- 8. Waldron-Engle Subdivision; KPB File 2022-147**

ITEM 8 – WALRON-ENGLE SUBDIVISION

STAFF REPORT

# Waldron-Engle Subdivision

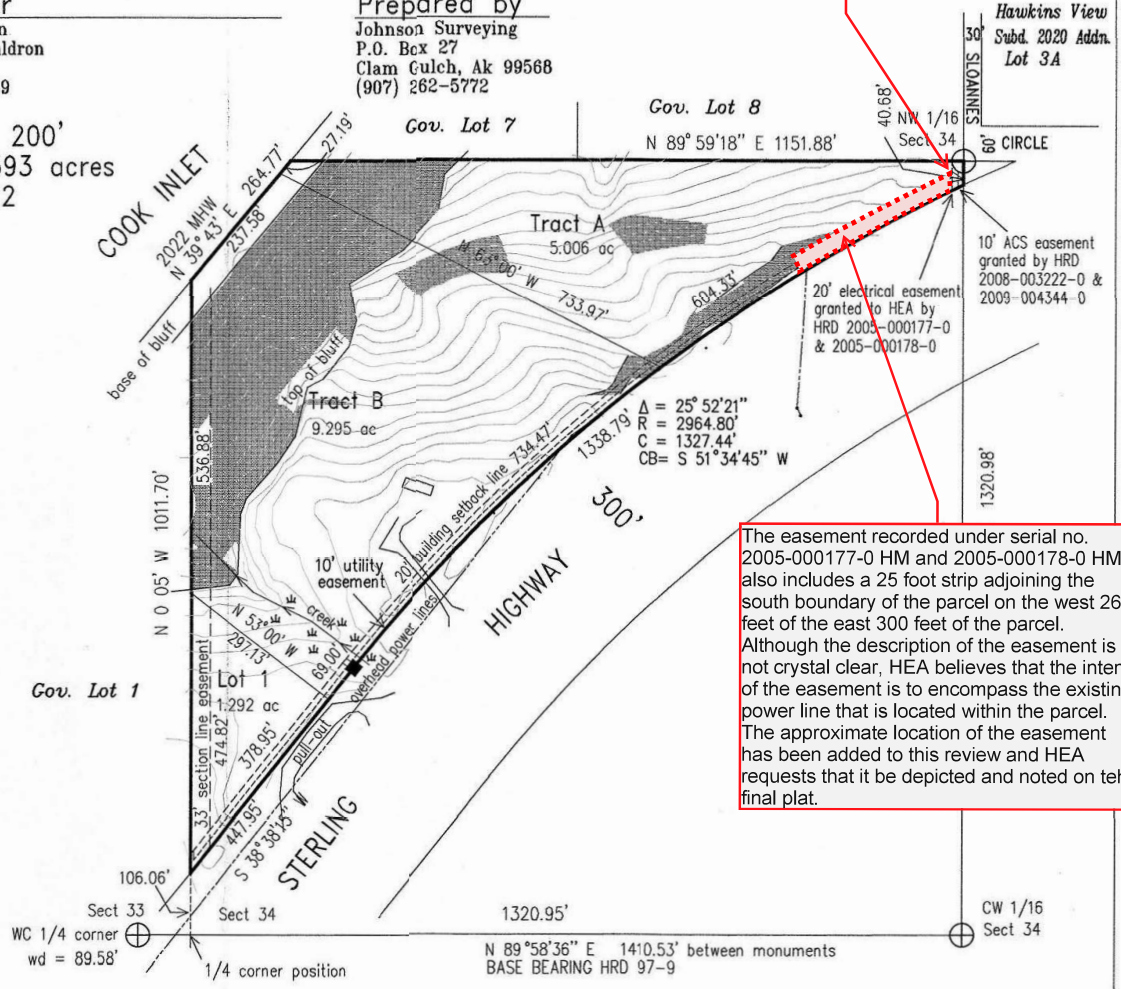
Verify the location of the 3 phase primary overhead electric line. If the line is located outside of the record easement, HEA requests that the line be depicted and a label or plat note be added stating, 'The existing overhead power line is the centerline of a 40 foot wide electrical distribution line, including guys and anchors, granted this plat.'

The easement recorded under serial no. 2005-000177-0 HM and 2005-000178-0 HM also includes a 25 foot strip adjoining the south boundary of the parcel on the west 260 feet of the east 300 feet of the parcel. Although the description of the easement is not crystal clear, HEA believes that the intent of the easement is to encompass the existing power line that is located within the parcel. The approximate location of the easement has been added to this review and HEA requests that it be depicted and noted on the final plat.
